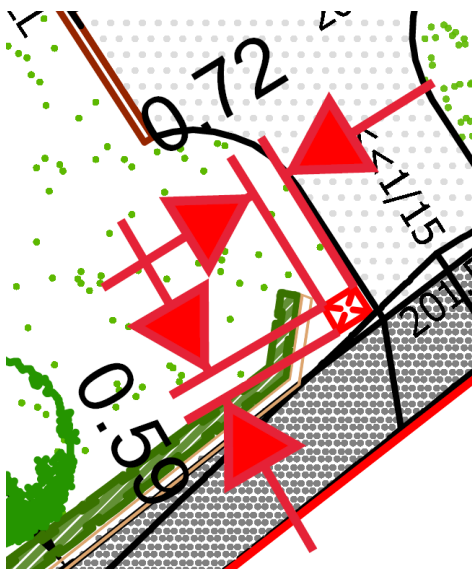
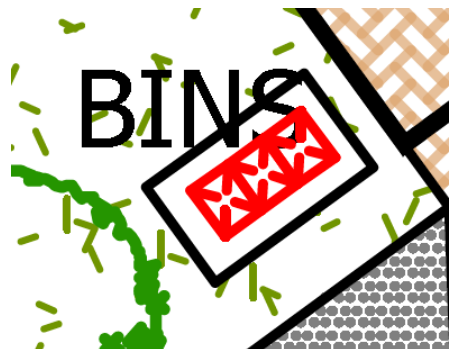
Looking at the applicant's plans, the symbol for bins can be seen where communal bins are proposed: *see right*.

This same symbol also appears at the entrance to the proposed drives.

The individual size allowance, based on the plan, for these bins, measures 720mm x 590mm: *see below*.

As such, there is only enough room for a single wheelie bin. And remember, the dimensions above are for a SMALL wheelie bin, not a NORMAL sized bin.

Yet, the houses where these bins are proposed are four and five bedrooms. As such, small wheelie bins seem totally inadequate. Not forgetting, Kirklees expect developers to accommodate 2 x 240L wheelie bins.

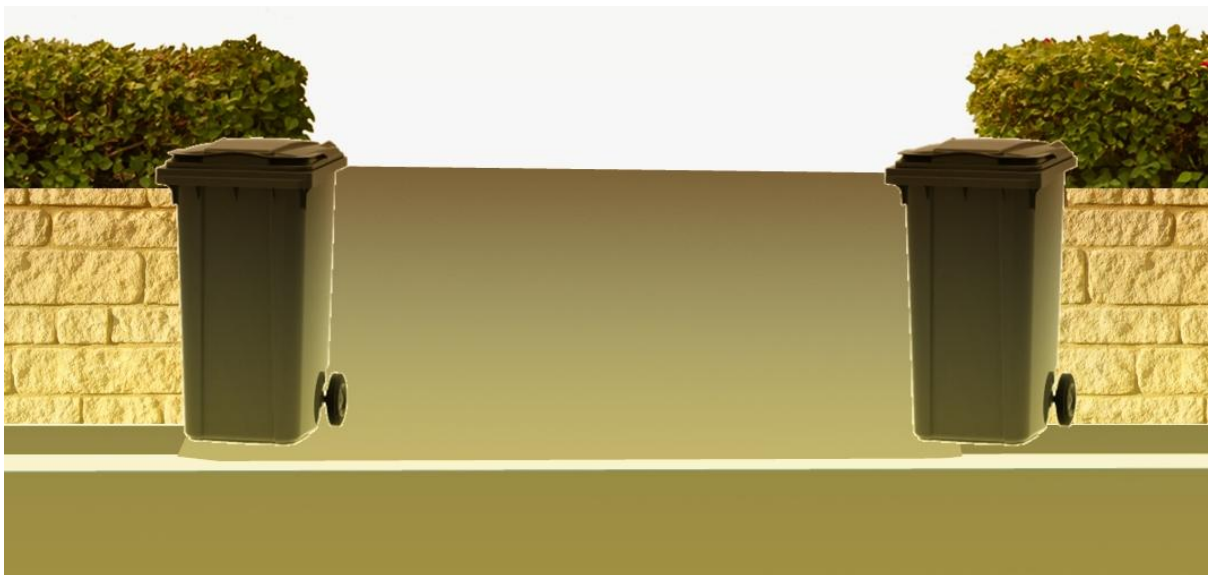
Below shows 11 proposed dwellings. The bin provision, as seen on the plan, would allow for 5 small wheelie bins. That would provide a mere 29% of the total provision expected by Kirklees.

But, not only are Kirklees' requirements still being ignored, the developer is essentially proposing the first sight new residents (and their visitors) will be welcomed with, arriving home, would be wheelie bin(s). For some reason, plot 42 has provision for two small wheelie bins, whereas most others get one.

Is this really good design? Is this even really what people paying £600-800K expect to see?

Placing bins at the entrance to driveways, in an area completely unsuitable for doing so, is evidently the opposite of being 'visually unobtrusive'.
